Kansas Department of Agriculture
 Division of Water Resources
CHANGE: P/D WORKSHEET

RE: Water Right, File No. 6227-A

RE: Application for Change in Point of Diversion
Water Right, File No. 6227A

Evaluation of proposed move for Water Right No 6227 A

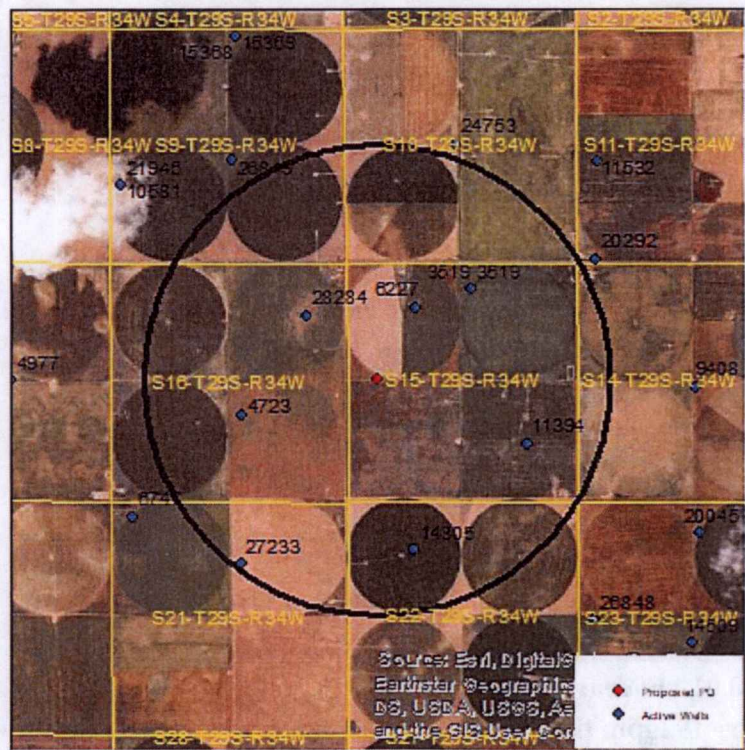
Proposed: Move water right no. 6227 A a distance of 1,822 ft to the southwest.

Wells within 1 mile: 3519, 11394, 14305, 27233, 4723, and 28284.

The saturated thickness at the proposed well location is estimated to be 239 ft, based upon the GMD3 model. For saturated thickness greater than 200 ft, the drawdown allowance is 4.0 ft.

50 year Theis Analysis: The following values were used to run the analysis:

$S = 0.05322$, $T = 12,348 \text{ ft}^2/\text{day}$, $t_{p\text{current}} = 198 \text{ days}$ (based upon average use and observed rate),
 $Q_{\text{current}} = 192 \text{ gpm}$ (based upon 2018 field inspection), $t_{p\text{proposed}} = 85 \text{ days}$, $Q_{\text{proposed}} = 854 \text{ gpm}$

| 3519: | Drawdown from current location = 1.50 ft |
| | Drawdown from proposed location = 2.90 ft |
| | Net drawdown = 1.4 ft |
| 11394: | Drawdown from current location = 1.00 ft |
| | Drawdown from proposed location = 2.49 ft |
| | Net drawdown = 1.5 ft |

Based upon information from the GMD3 model, this proposal will cause minimal effects on neighboring wells, and is unlikely to create an impairment. GMD3 staff recommends approval of the application.

WELL TEST ANALYSIS

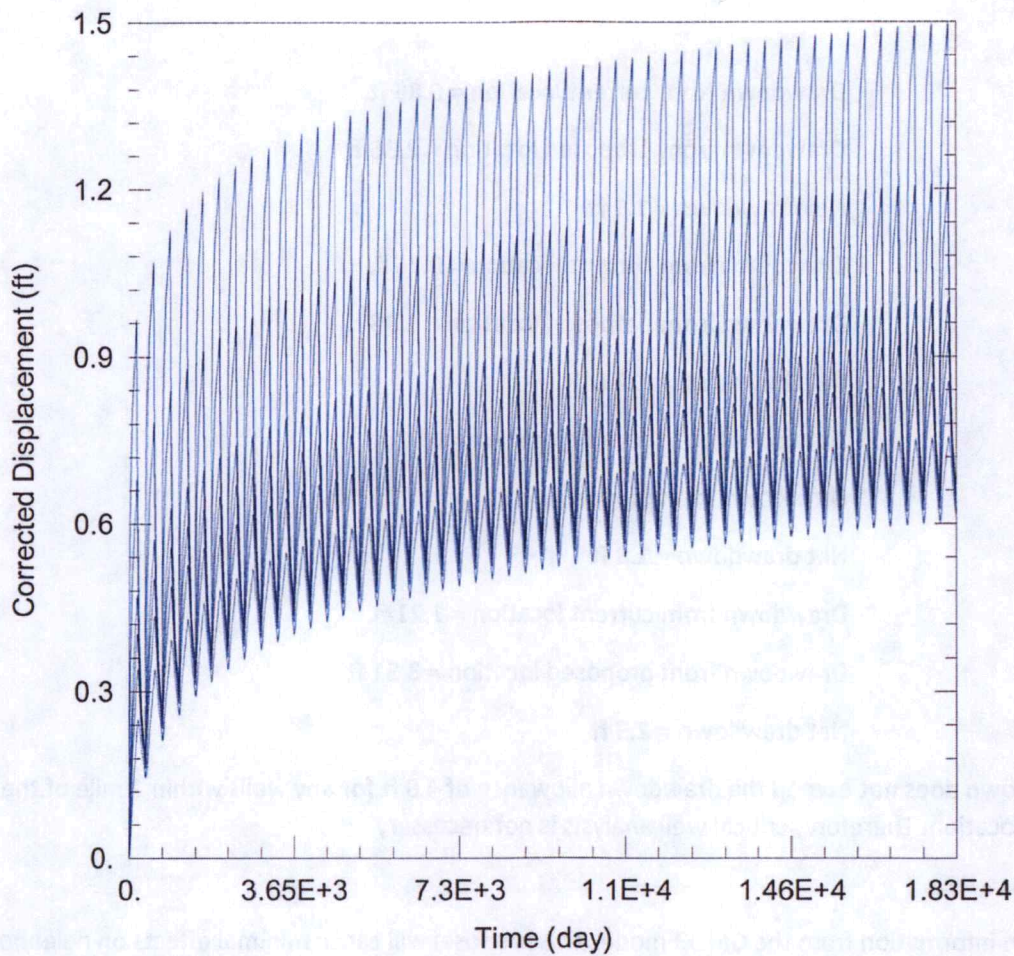
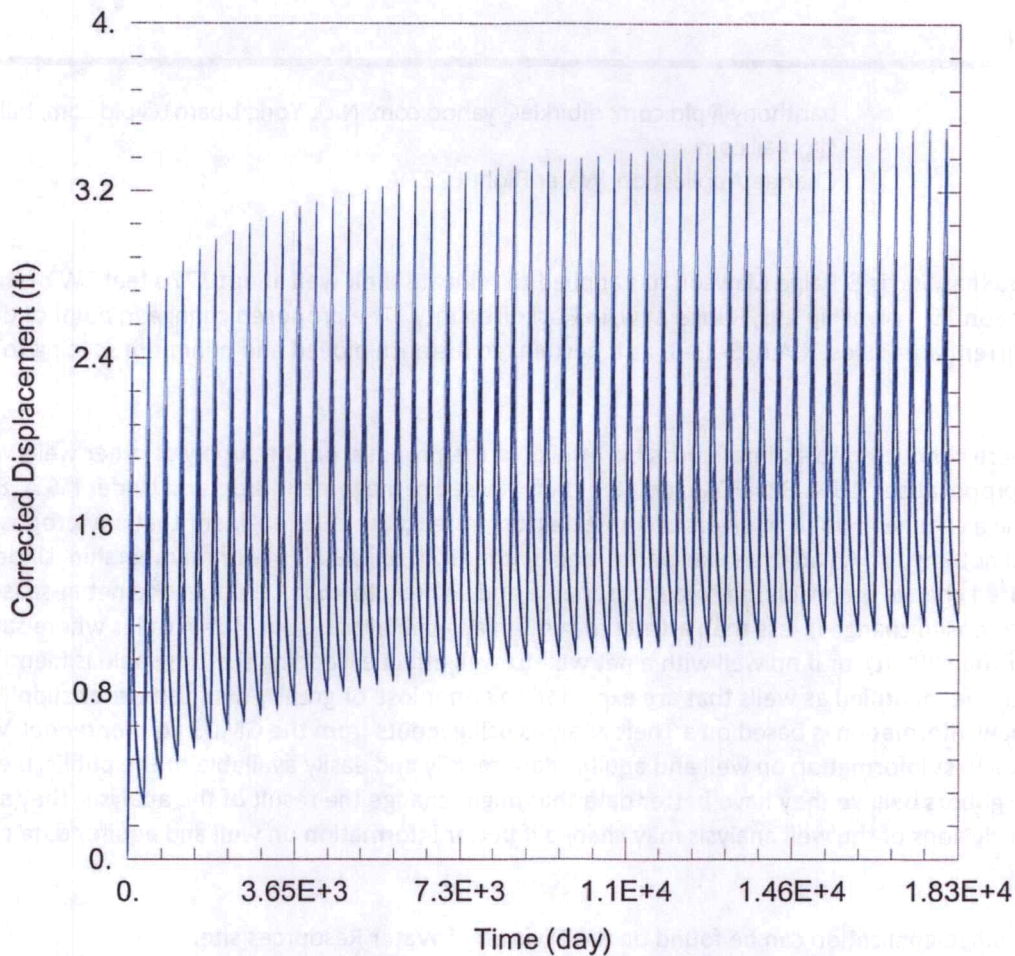
- 14305: Drawdown from current location = 0.85 ft
Drawdown from proposed location = 2.36 ft
Net drawdown = **1.5 ft**
- 27233: Drawdown from current location = 0.76 ft
Drawdown from proposed location = 1.96 ft
Net drawdown = **1.2 ft**
- 4723: Drawdown from current location = 0.93 ft
Drawdown from proposed location = 2.75 ft
Net drawdown = **1.8 ft**
- 28284: Drawdown from current location = 1.21 ft
Drawdown from proposed location = 3.51 ft
Net drawdown = **2.3 ft**

Net drawdown does not exceed the drawdown allowance of 4.0 ft for any wells within 1 mile of the proposed location. Therefore, critical well analysis is not necessary.
